**OIL SANDS CO-PRODUCTION EXPERIMENTAL PROJECT
SUPPLEMENTAL INFORMATION REGARDING
AEUB APPLICATION NO. 950993
AEP APPLICATION NO. 001-17233**

OCTOBER 1995

Subject: Application No. 001-17233
THE OIL SANDS CO-PRODUCTION EXPERIMENTAL PROJECT
LEASE 7276120T05

This submission is in response to a September 19, 1995 letter from the Alberta Energy and Utilities Board (AEUB) and a September 20, 1995 letter from Alberta Environmental Protection (AEP) to the SOLV-EX Corporation.

Figure A6. Maximum 1-hour average SO₂ concentration (ug/m³) results for the combined operation of the SOLV-EX (Phase II abnormal), Suncor and Syncrude facilities as predicted by ISCST2 (rural dispersion, elevated terrain, SandAlta meteorology).

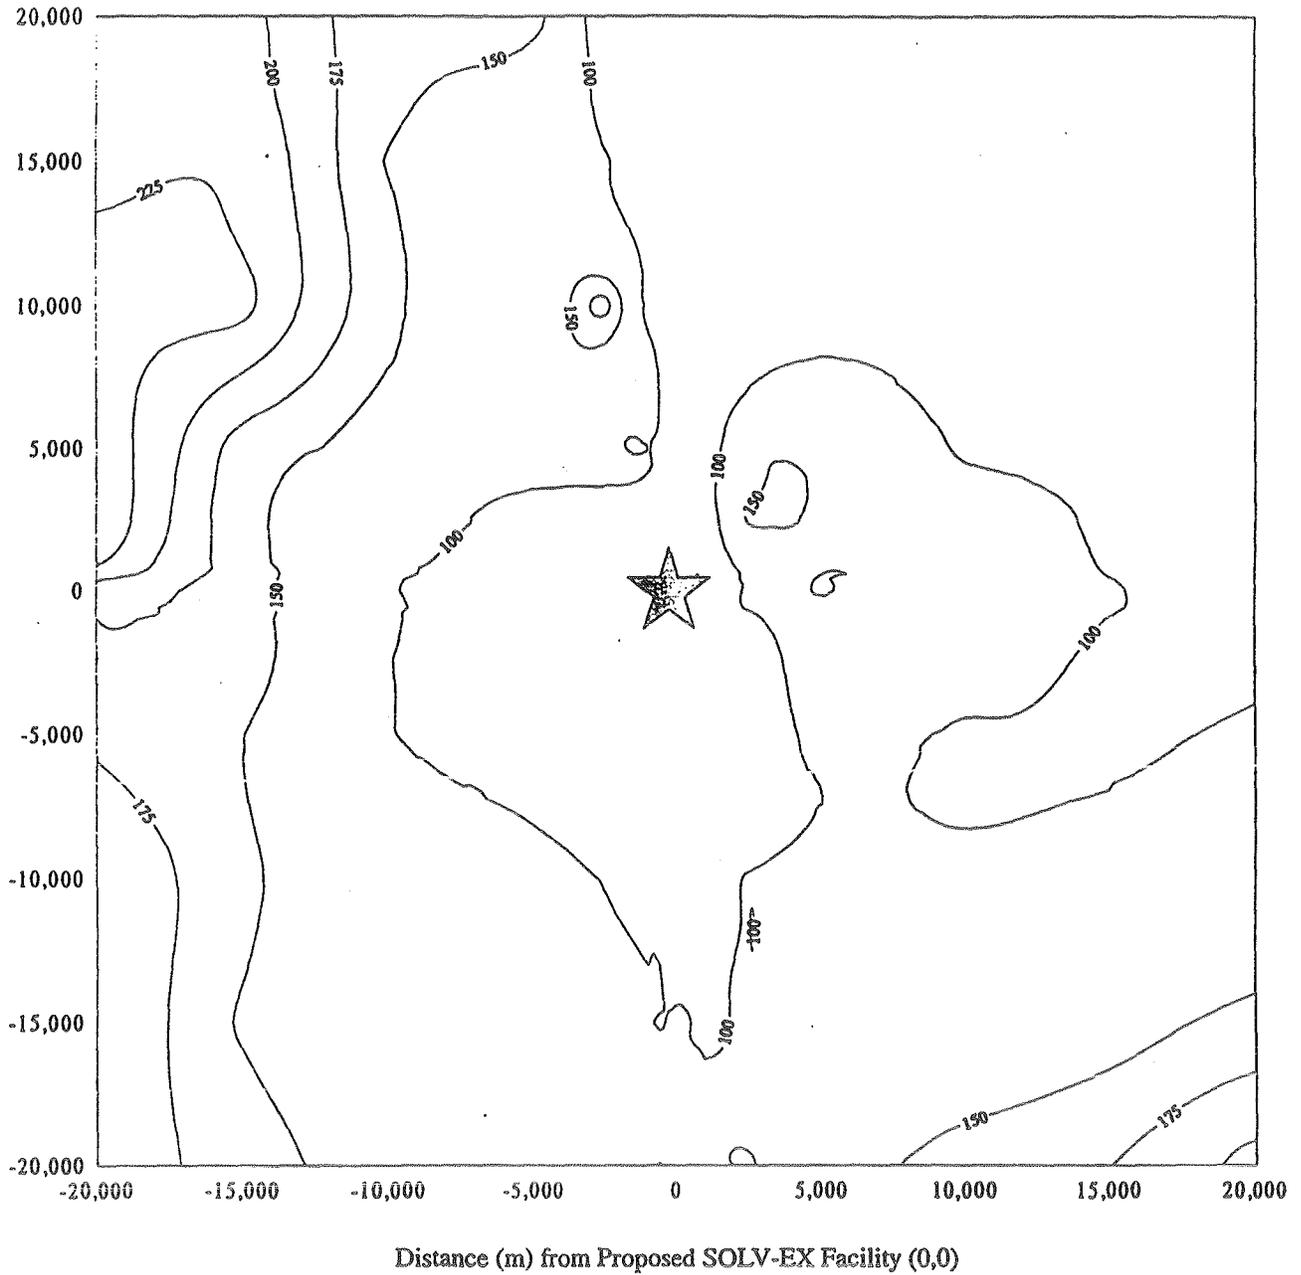
For the dispersion modelling results presented in Table A6 (Appendix A), please clarify what input parameters were used for Suncor and Syncrude air emissions for each of the models.

- The ISCST2 model simulates the effect of Suncor and Syncrude emissions in a 40 by 40 km area centred on the SOLV-EX site (Figure A2 of Appendix A). The maximum predicted hourly SO₂ concentrations in the region is 246 µg/m³. This value occurs 20 km west of the SOLV-EX site and is associated with elevated terrain (Birch Mountains). A secondary maximum of 155 µg/m³ is also associated with elevated terrain (Fort Hills, 5 km northeast of the SOLV-EX site). All the maximum SO₂ values shown in the figure are associated with southerly winds.

- The ISCST2 model was re-run with the SOLV-EX normal and abnormal emissions (Figures A3 and A4, respectively) for both Phase I and Phase II. In Phase II, the maximum value associated with the **normal** case is 146 µg/m³. This maximum is associated with Fort Hills and occurs 3.5 km to the northeast of the proposed plant site. The maximum value associated with the **abnormal** case is 149 µg/m³ and this value is predicted to occur 5 km to the northeast.

- The ISCST2 model was re-run using Syncrude and Suncor emissions with SOLV-EX normal and abnormal emissions, respectively. Figures A5 and A6 show the results. The addition of the SOLV-EX operation does not change the maximum predicted value of 246 µg/m³ which is predicted to occur 20 km west of the proposed SOLV-EX site.

together with the Suncor and Syncrude SO₂ emissions. The result is shown in Figure A1, where the design guideline is 450 µg/m³ as described by the above presented equation. In order to determine the maximum ambient SO₂ guideline for SOLV-EX, each of the sources was modelled individually at the meteorological conditions associated with the maximum prediction (shown to occur in the Fort Hills area, approximately 3.5 km northeast of the SOLV-EX site). From this exercise, it was determined that the contribution from Suncor and Syncrude was zero under the conditions causing the maximum in the vicinity of the SOLV-EX site. Thus, from the equation, the effective ambient SO₂ limit for SOLV-EX is 150 µg/m³.
